Mallinckrodt Chemical Works
Mallinckrodt/Nuclear
ATTN: Mr. Norman E. Drissell
Director of Operations
Box 10172 Lambert Field
St. Louis, Missouri 63145

This refers to an inspection conducted by Mr. Ashley of our Region III Compliance Office in May 1971 of your activities authorized under AEC Byproduct Material License No. 24-04206-01, and to the discussion held with Messrs. Drissell and Saldan by Mr. Ashley at the conclusion of the inspection.

INSPECTION REPORT - MALLINCKRODT CHEMICAL WORKS, MALLINCKRODT/NUCLEAR
ST. LOUIS, MISSOURI - LICENSE NO. 24-04206-01

COMPLIANCE INSPECTION REPORT

MALLINCKRODT NUCLEAR
 BUILDING 300 PLAN
 SCALE: 1" = 20'

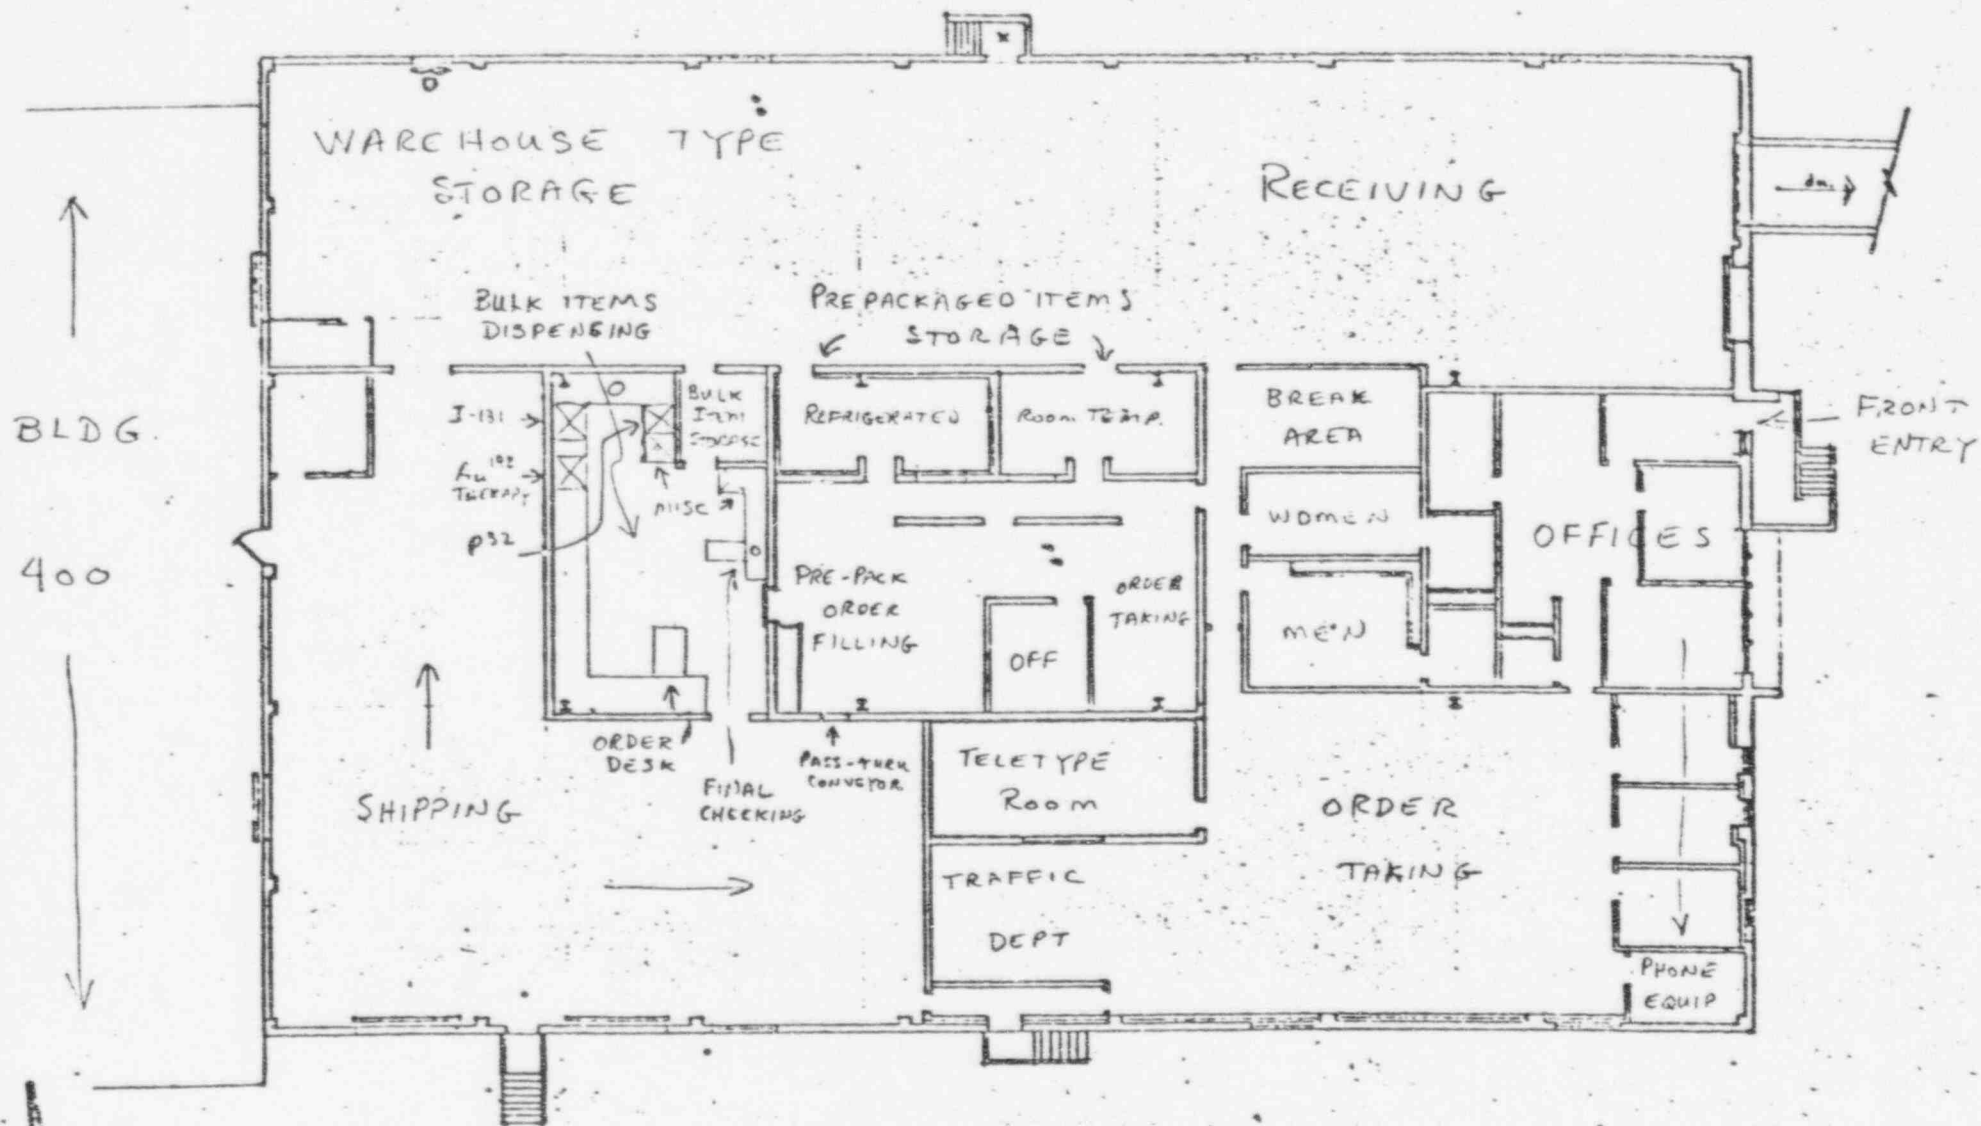
2. Contrary to 10 CFR 20.201(b), "Surveys,"
 - a. no surveys for airborne radioactive material were performed of the exhaust stack effluents from the Building 300 dispensing laboratory during the period January 11, 1971, to May 11, 1971, to determine compliance with 10 CFR 20.106(a);

- b. no surveys were performed for airborne radioactive material to which individuals were exposed in the Building 300 dispensing laboratory during the period January 11, 1971, to May 10, 1971, to determine compliance with 10 CFR 20.103(a); and

With respect to Items 2a and 2b above, it was observed by the inspector that air samples of the Building 300 exhaust air vent system and in the operating areas were being taken as of May 10 and 11, 1971, respectively. However, because of the four-month period when no air samples were taken in these areas, it appears that improvement is needed in the management of the company's radiation safety program. Your reply should emphasize, in particular, any appropriate changes that have been or will be made to improve the effectiveness of your management control systems.

44. During this inspection, it was noted that the Building 300 rooftop sampling was begun on May 10, 1971, while the stack sampling of the one stack that serves the gloveboxes in the Building 300 dispensing laboratory was begun on May 11, 1971. The dispensing operations in Building 300 dispensing laboratory began on January 11, 1971, according to licensee representatives. The failure of the licensee to perform stack and rooftop sampling at the Building 300 location between the period January 11, 1971, and May 10 and 11, 1971, constitutes noncompliance with 10 CFR 20.201(b) in that no surveys or evaluations were made to determine compliance with 10 CFR 20.106(a). It is noted that at the time that the Building 300 dispensing laboratory went into operation on January 11, 1971, the licensee has had a 12 inch x 12 inch x 8 inch Barneby Cheney Model 7DF charcoal filter serving the exhaust of the iodine 131 processing box and a 24 inch x 24 inch x 12 inch absolute filter, with a prefilter, located on the roof of Building 300 which commonly serves all of the glove boxes.
